Re: **Wyoming Mall-Starbucks**
Project #: PR-2021-005461
Application #: SI-2023-01170

Please find the following responses addressing comments received in a letter dated July 18, 2023. In an effort to address your comments concisely and simplify your review of these development plans, we have summarized your comments and our responses below. Your comment is listed first, followed by the response in Bold.

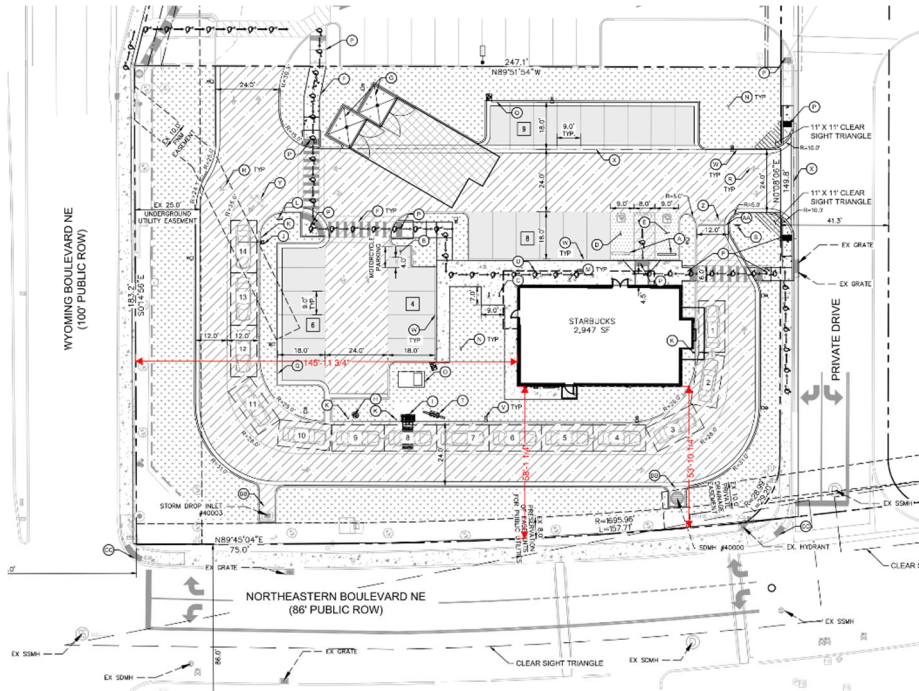
Comment 7: Please provide a detailed explanation letter and include site plan notes as to how the proposed elevation is meeting all applicable sections of 5-11(E) of the IDO.

Response 7: Below is the site plan and the measurements from the street facing façade to the property line. According to the IDO each street facing façade within 30 ft of a property line (the measurement shall be made to the closest perpendicular plane of a primary building façade) has to follow 14-16-5-11(E).

This site has 2 street facing façades (Wyoming and Northeastern). From the property line to the closest point on the street facing façade along Wyoming is approximately 146'. From the property line to the closest point on the street facing façade along Northeastern is approximately 54'. Since the street facing facade exceeds 30ft from the property line 14-16-5-11(E) is not applicable,
